INTEROFFICE MEMORANDUM

TO: BRIDGE DESIGN PERSONNEL
FROM: Veral Pinkerton, Bridge Engineer
SUBJECT: Changes in Detailing Practices

CAP SECTION
INT. BENT

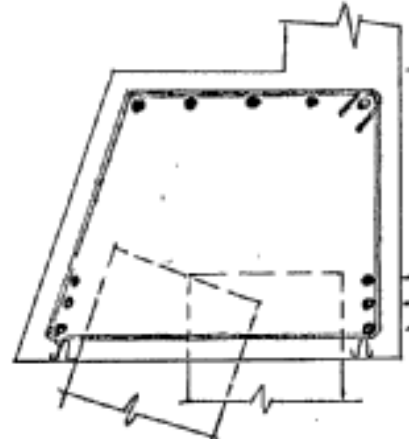
Field Inspections by Federal Highway Administration personnel has brought to my attention the fact that difficulty has been experienced in holding in place the four reinforcing bars in the bottom of pile bent caps which are shown near the piles and lapped at the ends.

On future details show the bars adjacent to the ties as shown on the attached sheet. Also add dimensions to set the location of these bars vertically.

Bars B2 and B3 should be alike if practical, and be U bars. Lap at ends. For End Bents vary laps so bars may be alike.

B2 & B3 marked for location and will not be same length as Int. Bent.

Straddle all bars
